| Model | DH100 | Volt/Hz | Date of Modification | Serial Number |
| Modified Article | Separation Belt - 9pcs/set and Bracket - Upper Original Sensor | | | |
| Reason for Modification | As per field request | | | |

#48
P/N VFE60043

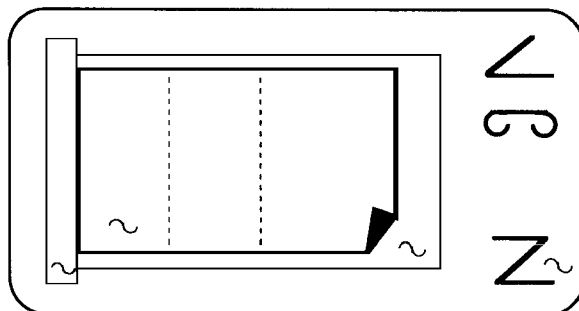
As per field request, the following parts have been registered as a service part. The single separation belt (VFA34598) is also still available.

| Part Number | Description | Index No. | Page |
|-------------|---------------------------------|-----------|------|
| VFE60043 | Bracket - Upper Original Sensor | *48 | 15 |

Page 15

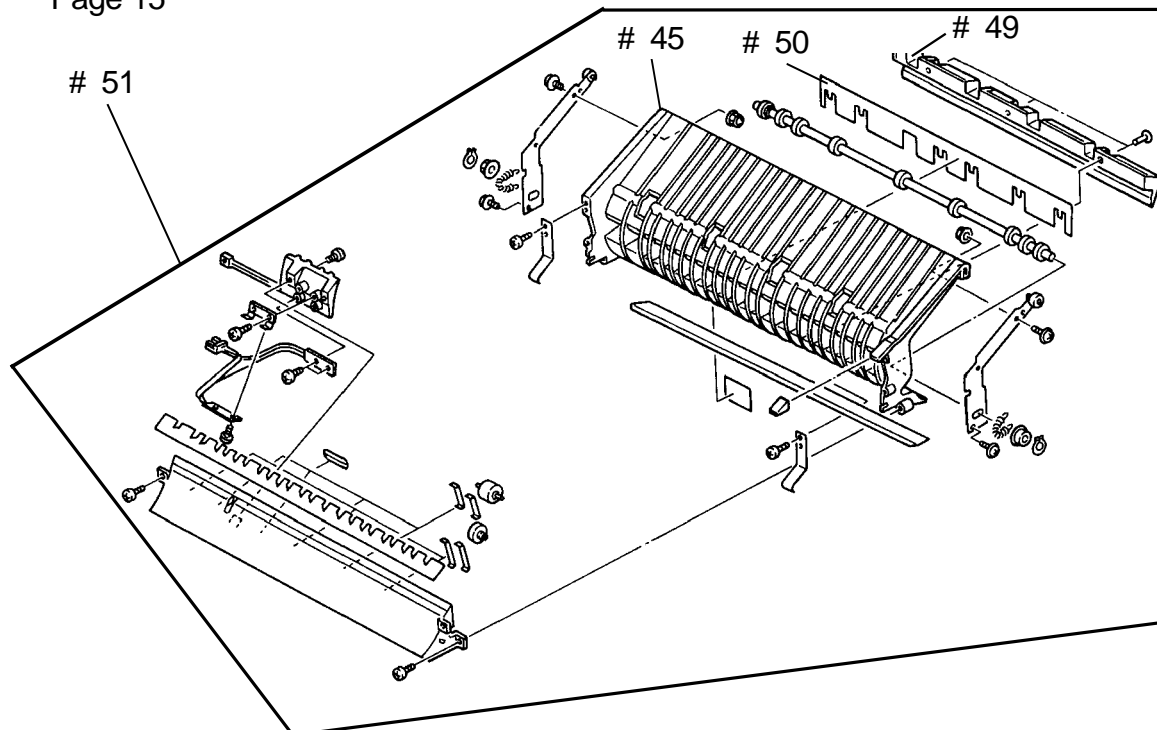
Please correct your parts catalog as follows:

| Incorrect P/N | Correct P/N | Description | Q'ty | Index No. | Page |
|---------------|-------------|----------------|------|-----------|------|
| VFA42403 | VFA34606 | Feed-out Guide | 1 | 45 | 15 |

| | P/N | Description | Q'ty | Index No. | Page |
|-----------|----------|----------------------|------|-----------|------|
| Incorrect | VFA34674 | Feed-in Sensor Plate | 1 | 40 | 7 |
| Correct | VFE60101 | Sensor Plate | 1 | 40 | 7 |

2. Addition

| P/N | Description | Q'ty | Index No. | Page |
|----------|------------------------|------|-----------|------|
| VFA42403 | Feed-in Guide | 1 | * 49 | 15 |
| VFA34610 | Feed-in Guide Myler | 1 | * 50 | 15 |
| VFG13764 | Paper Feed Guide Ass'y | 1 | * 51 | 15 |
